Subject: Solution Leakage & Low Solution Flow

Models Affected:

ECO#: A-03314, A-03816

Fig 1-

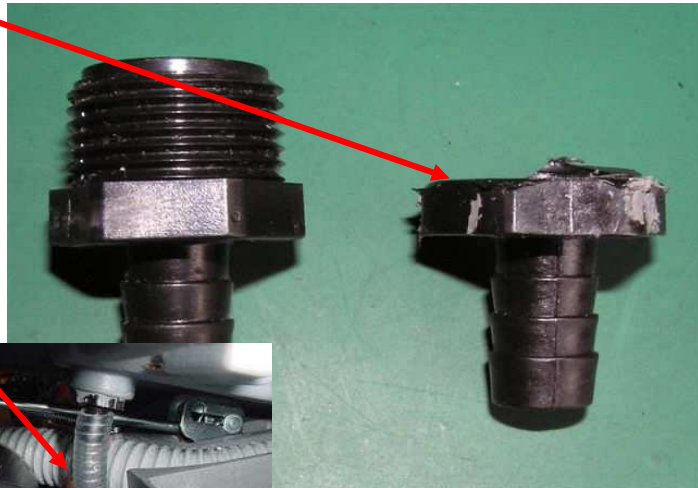
Fitting 56409507
fractured at hex

Hose incorrectly routed on
top of vacuum can stress
fitting. Hose fitting
fractured at hex.

Hose correctly
routed under
vacuum hose.

Fig 2-

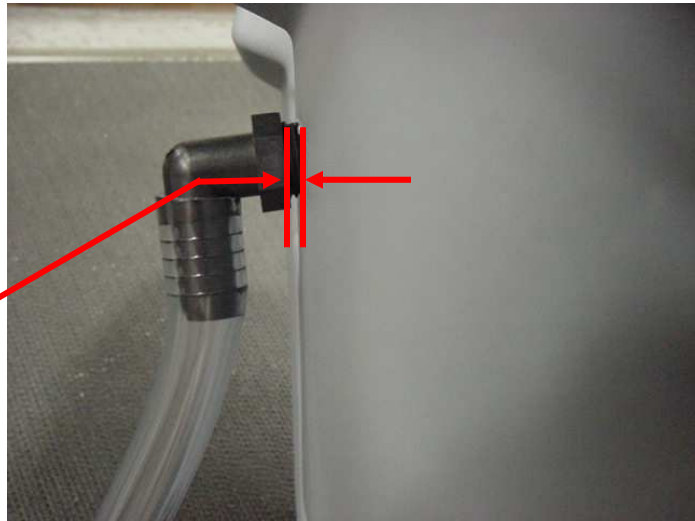
90 degree elbow 56900069
fractured at pump inlet & on
back of solution tank from
being over torqued.

Fig 3-

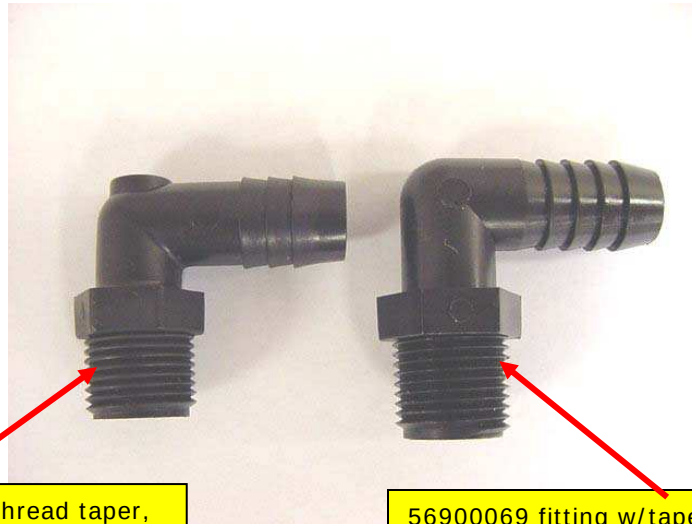
If fitting has straight threads it can be installed so nut is flush with tank. If fitting has tapered threads it should be installed so there is a 1/8 gap between nut and tank surface. Tightening until nut contacts tank can result in over torquing and cracking or fracturing fitting.

!CAUTION: When using aftermarket replacement fittings thread design can vary resulting in over tightening and cracking fitting.

56900069 fitting w/no thread taper,
0.63" dia.
Hex 0.68 inches across flats
3 barbs

56900069 fitting w/tapered
thread, 0.66-0.68" dia.
Hex 0.75 inches across flats
4 barbs

Fig 5-

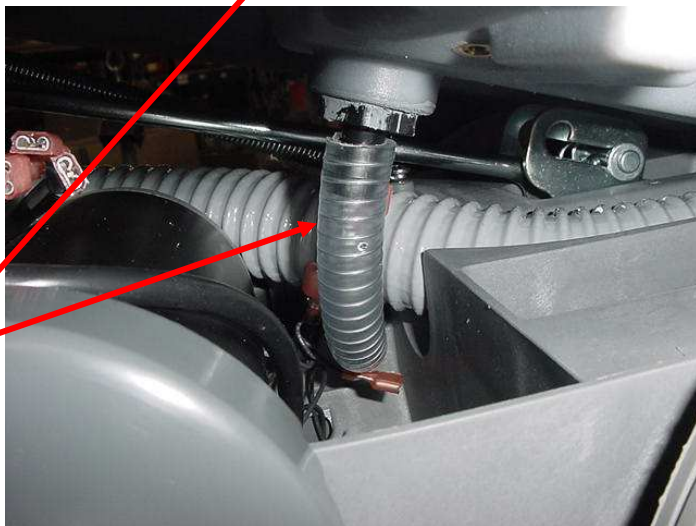
Straight fitting 56409057 initially used in pump inlet port was replaced with 90 deg elbow shown in Fig 6. Hose routing revised to reduce stress being applied to tank and pump fitting.

Fig 6-

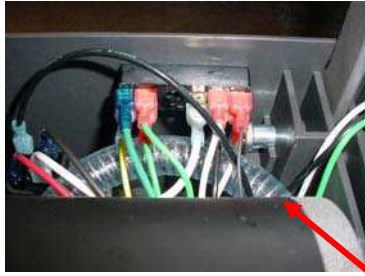
Straight fitting 56409507 changed to 90 deg elbow 56900069.
